APPLICATION NO.	FILING DATE	FIRST NAMED INVENTOR	ATTORNEY DOCKET NO.	CONFIRMATION NO.
10/538,508	01/06/2006	Andrew Charlton Clothier	424662011500	1875
25227 7590 01/24/2007 MORRISON & FOERSTER LLP 1650 TYSONS BOULEVARD SUITE 300 MCLEAN, VA 22102			EXAMINER	
			RO, BENTSU	
			ART UNIT	PAPER NUMBER
			2837	
SHORTENED STATUTORY PERIOD OF RESPONSE		MAIL DATE	DELIVERY MODE	
3 MONTHS		01/24/2007	PAPER

FINAL REJECTION

[insert drawing #1]

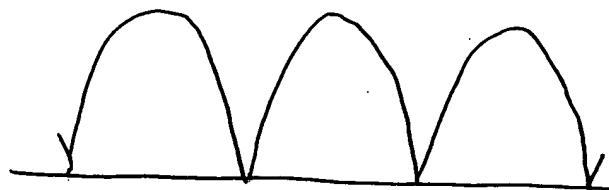
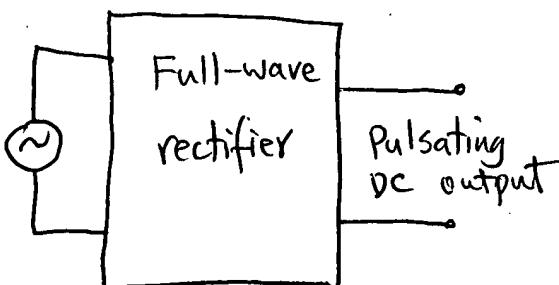
This requires a special knowledge in the rectifier circuit. The following is the examiner's explanation and interpretation.

The following circuit and waveform show a full-wave rectifier without a smoothing capacitor and without a load.

[insert drawing #2]

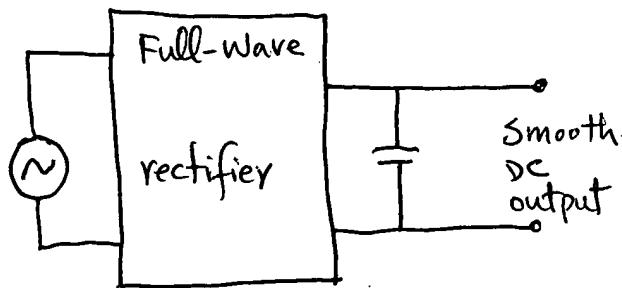
The following circuit and waveform show a full-wave rectifier with a smoothing capacitor but without a load.

[insert drawing #3]

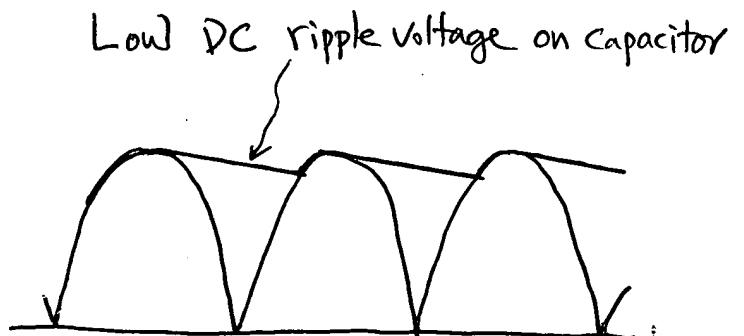
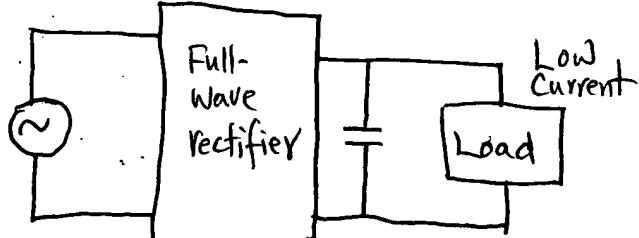
The following circuit and waveform show a full-wave rectifier with a smoothing capacitor and with a low current load.

[insert drawing #4]

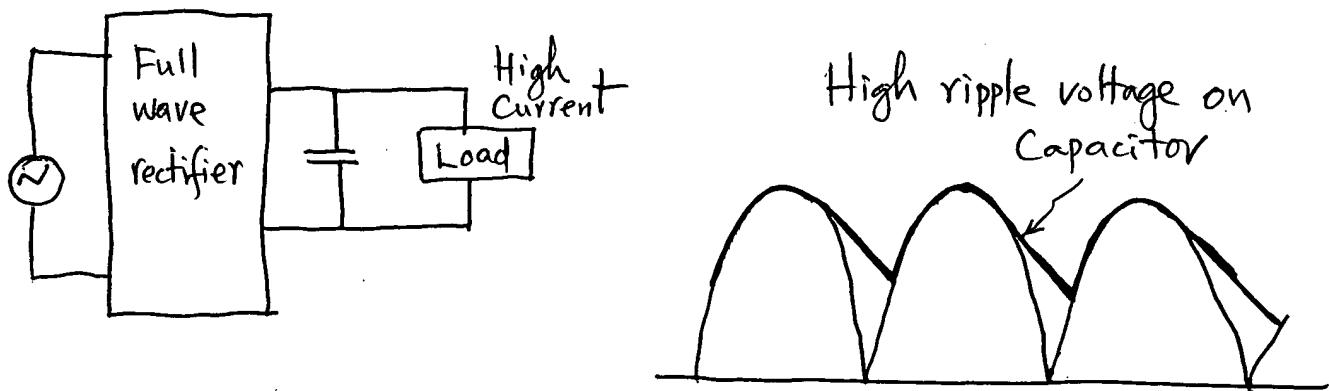
The following circuit and waveform show a full-wave rectifier with a smoothing capacitor and with a high current load.

[insert drawing #5]

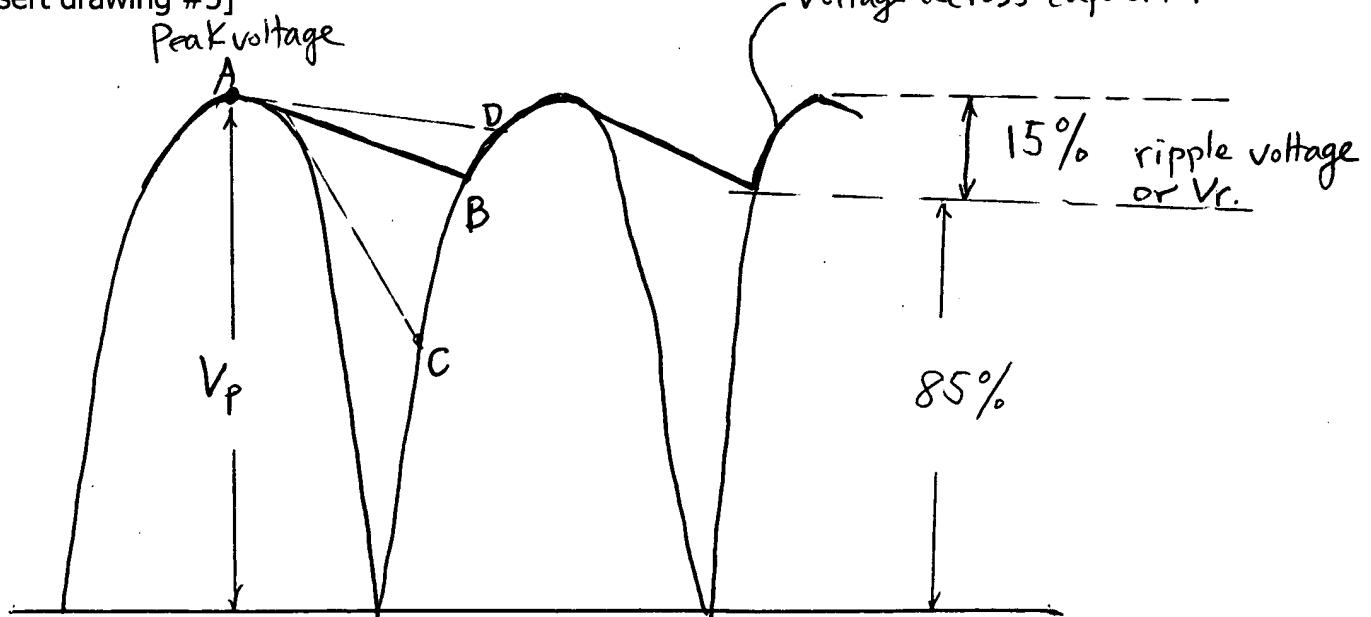
Explanation and interpretation of claim 1 with drawing showing the details.

V_p = nominal peak rectified voltage.

Points:

- A ----- the nominal peak rectified voltage;
- B ----- exactly below 15% of the peak voltage;
- C ----- falls below 15% of the peak voltage;
- D ----- falls above the 15% point.

Because claim 1 calls for "the voltage across the capacitor falls below 15% of the nominal peak rectified voltage of the source during each cycle of the alternating source." (Emphasis added.).

Point D cannot be "falls below 15%", only point C can because the peak voltage is at point A, and 15% below A is B. Fall below 15% should be any points below point B, that is point C, not point D. Therefore, the examiner's interpretation is accurate and correct.
